INSPECTION REPORT (CLIENT'S FORMAT)

Product Description:	Poison Series Cues / 17 items				
	Report number:				
	Inspection Date :				
	Service Item.:	<input checked="" type="checkbox"/> PSI	<input type="checkbox"/> IPI	<input type="checkbox"/> DPI	
		<input type="checkbox"/> PM	<input type="checkbox"/> FI	<input type="checkbox"/> RE-PSI	
	Customer:	Predator Group			
	Customer P.O.:				
	Vendor:				
	Ship to.:	<input checked="" type="checkbox"/> USA	<input type="checkbox"/> China(Laili)		
Location Area	Zhangzhou, Fujian, China

BK-3 LW, S/N.: 4DVK 58F

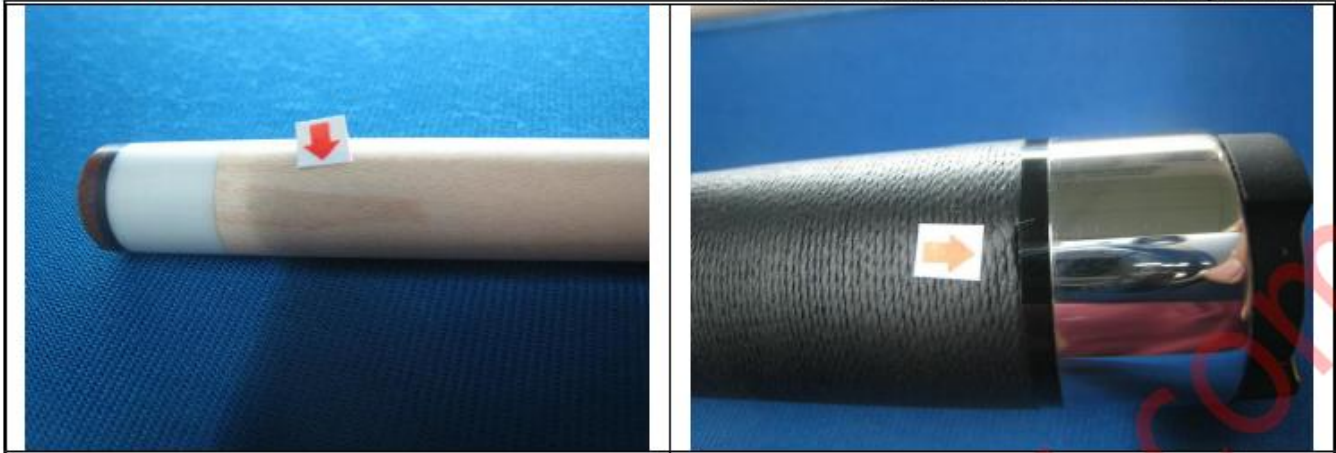
Black stain

Not sharp edge on logo

BK-3 LW, S/N.: 4DVK 5AE

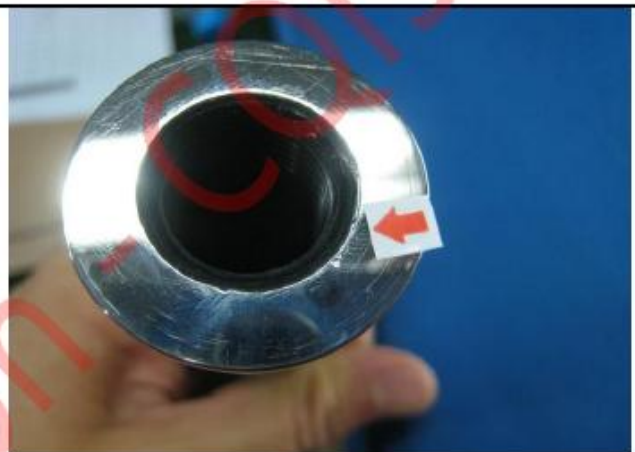
Not sharp edge on logo

Unclear S/N

BLT1, S/N.: 1DSK 67C

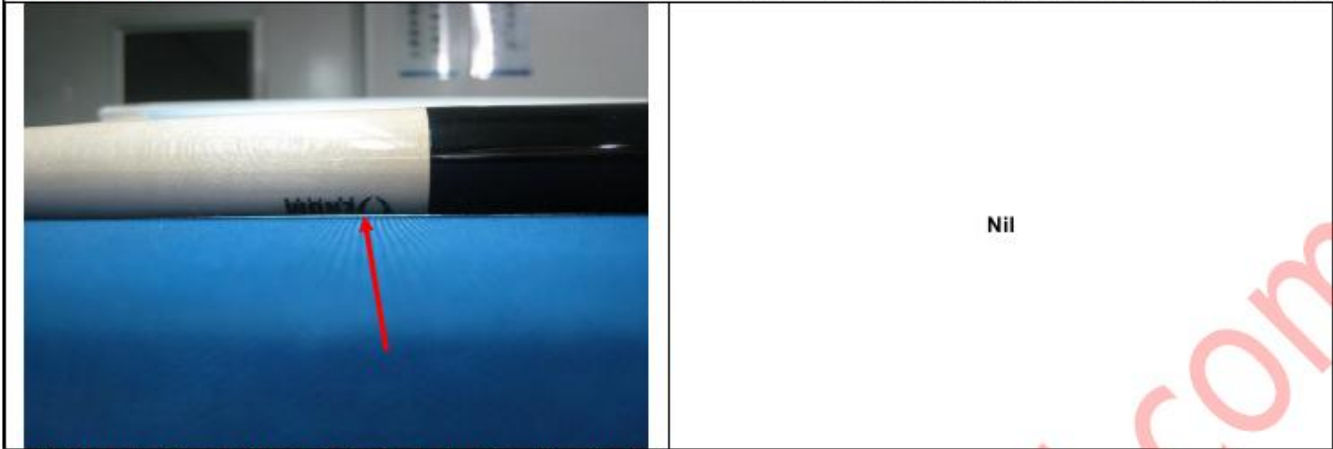
Color stain

Stain, but removable

Wobble test after shaft installed with butt-one direction is straight , after rolling the cues

Wobble test after shaft installed with butt- other direction is wight slight gap, after rolling the cues

Wobble test after shaft installed with butt- other direction is wight visible gap, after rolling the cues
